Discuss : Pier Reinforcing Steel @ Pond*****

REVISED BOARDWALK LAYOUT PLAN

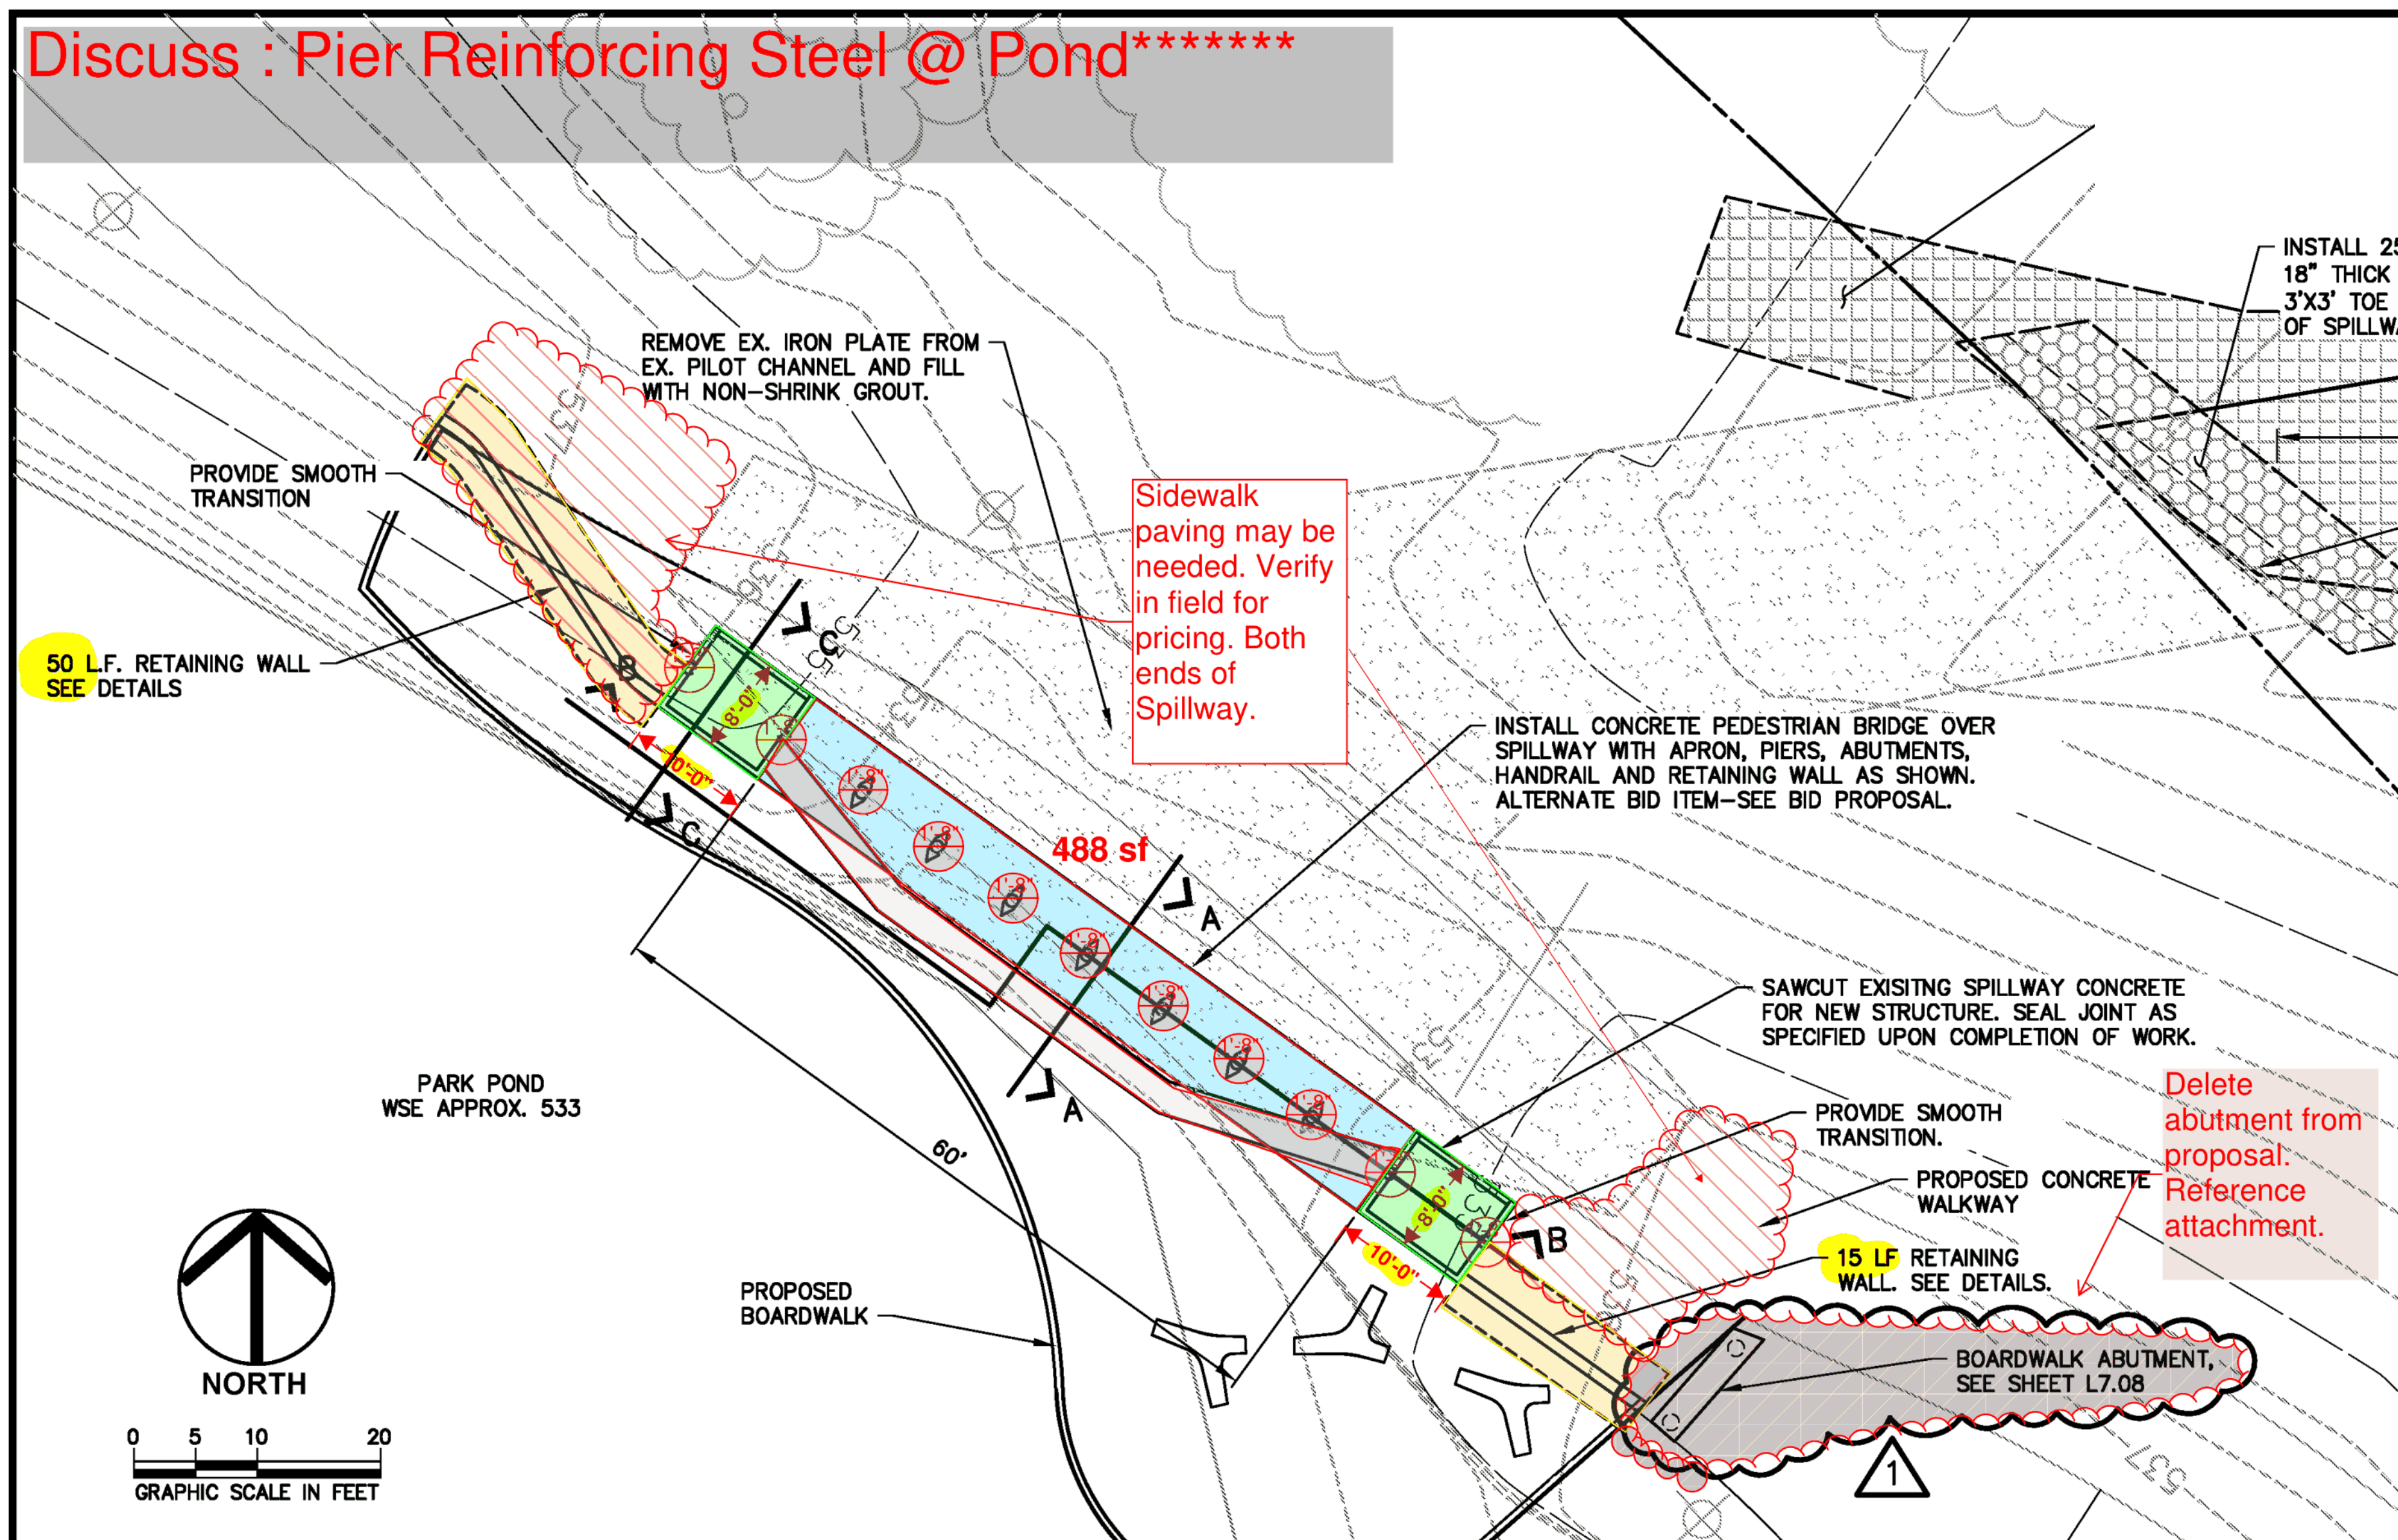
Boardwalk Abutment (Per this sheet & L5.05): Remove from estimate

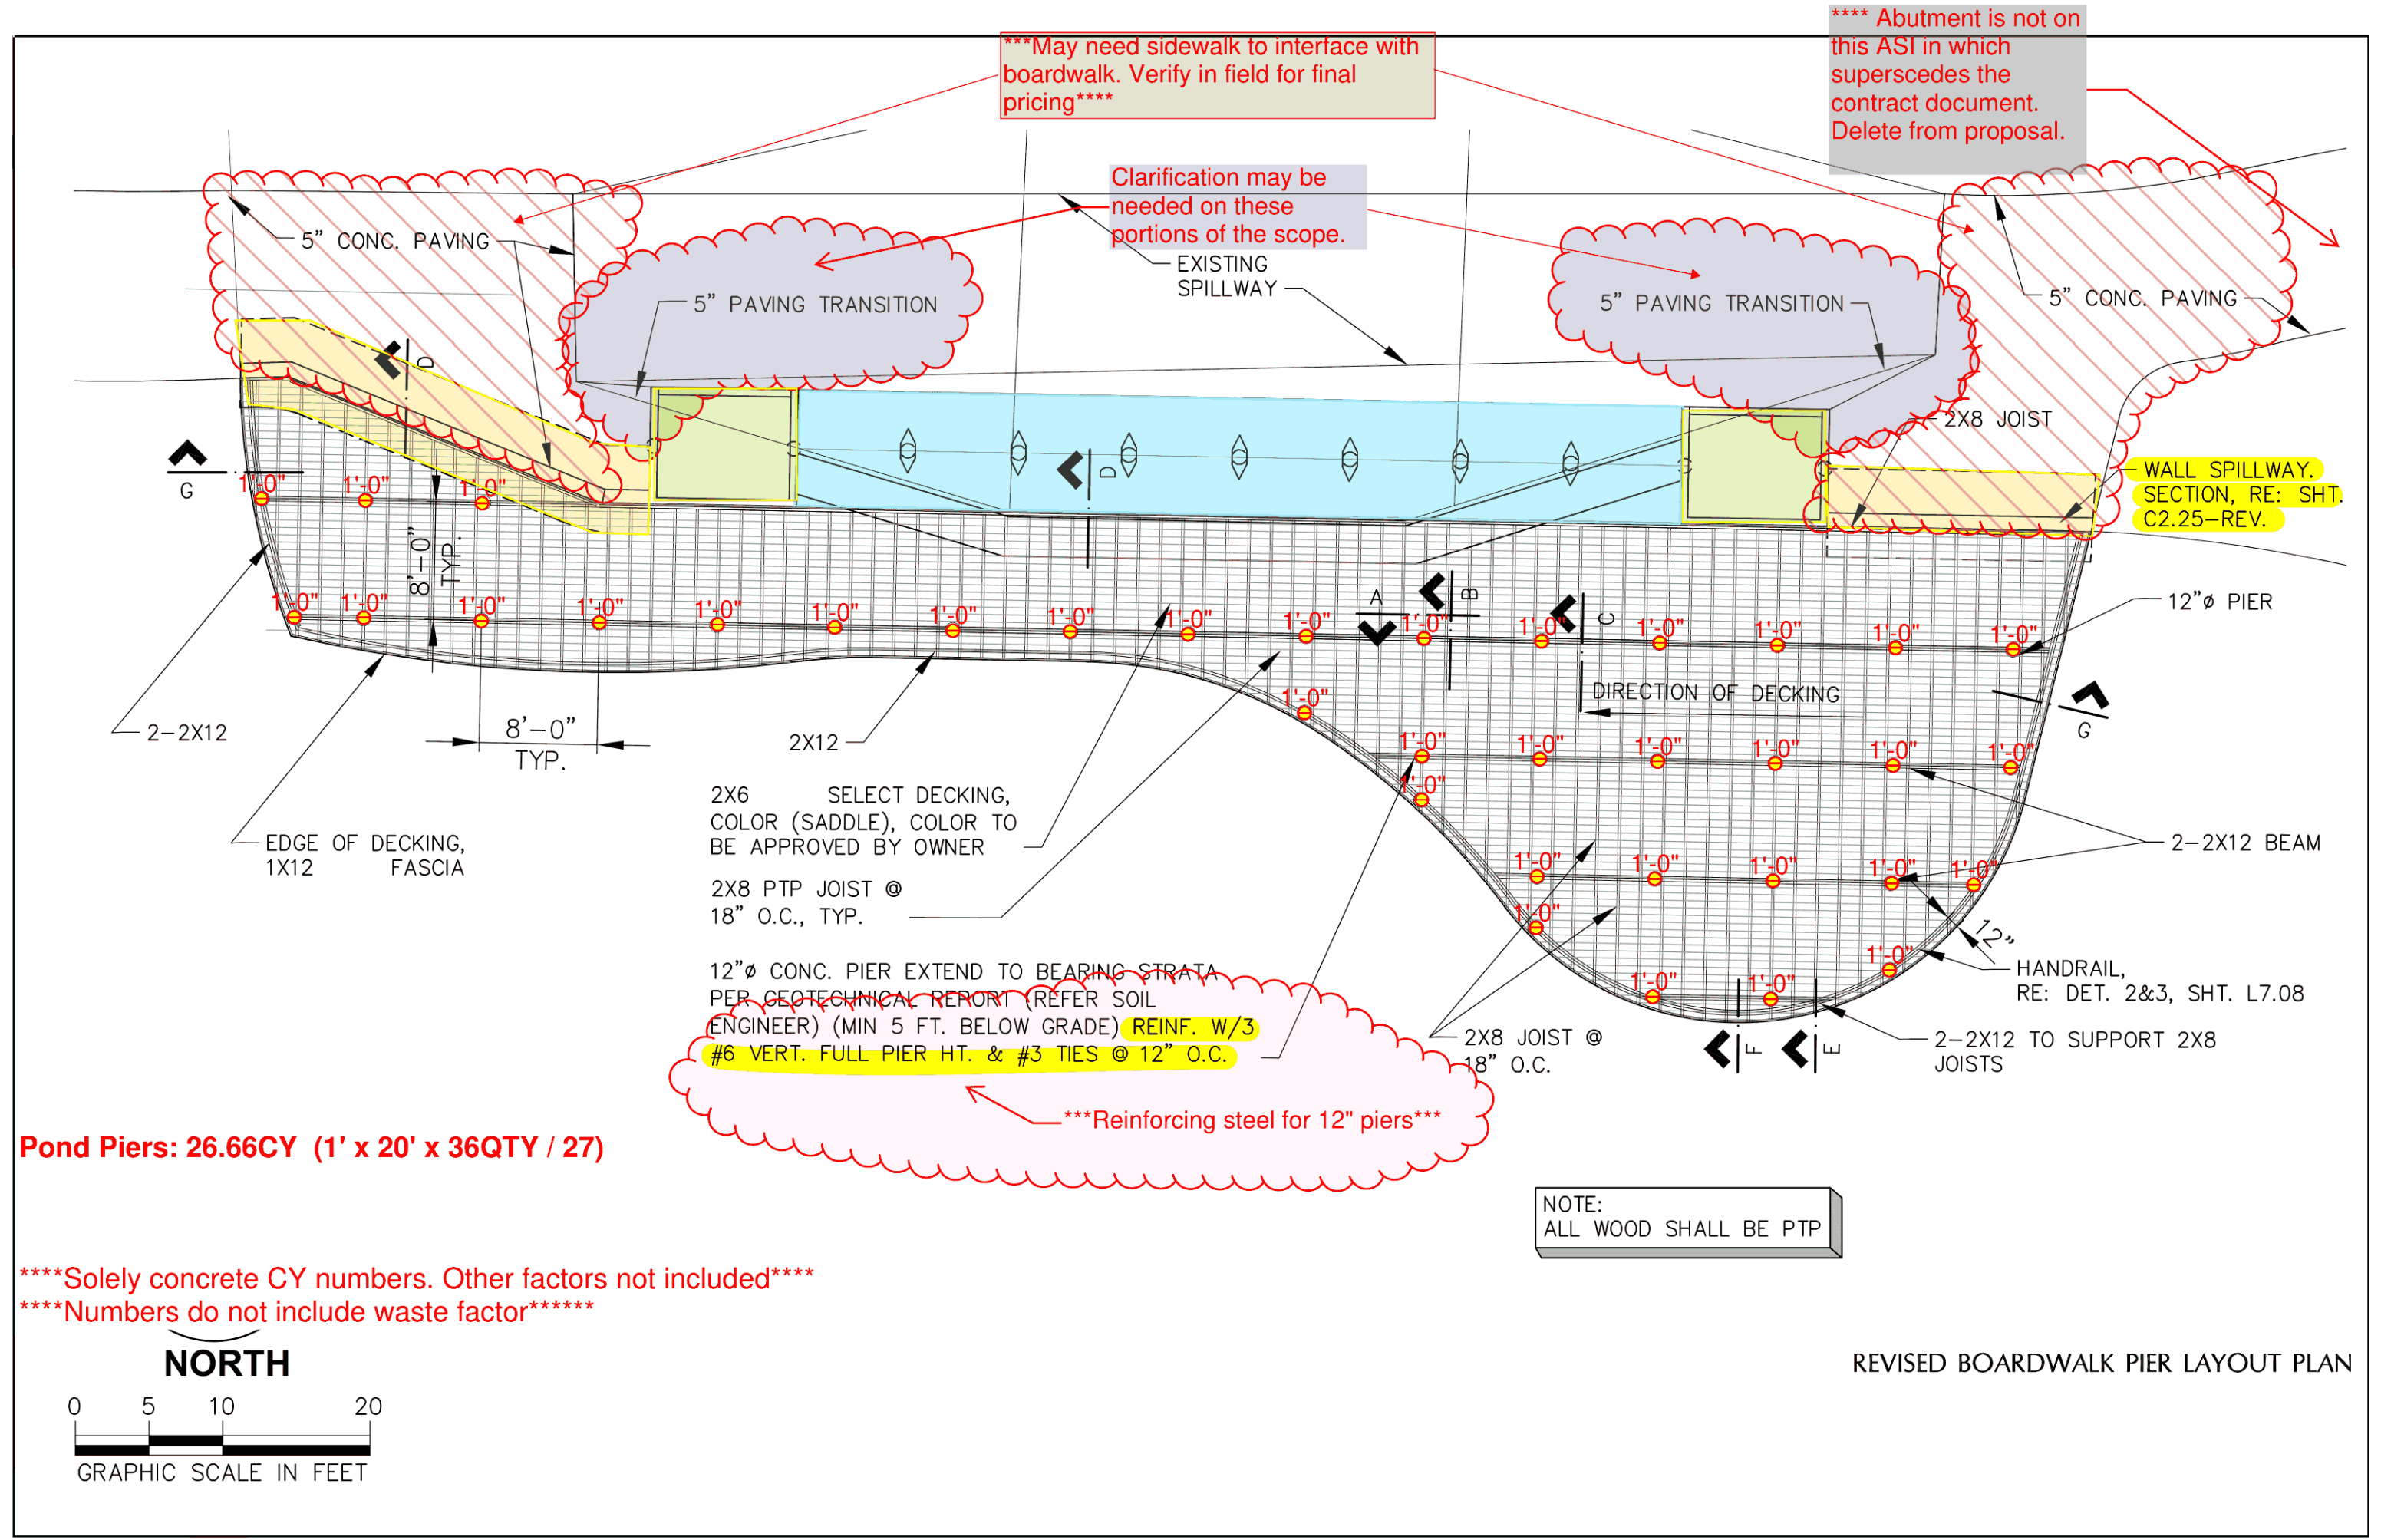
May need sidewalk to interface with boardwalk. Verify in field for final pricing

**** Abutment is not on this ASI in which supersedes the contract document. Delete from proposal.

Clarification may be needed on these portions of the scope.
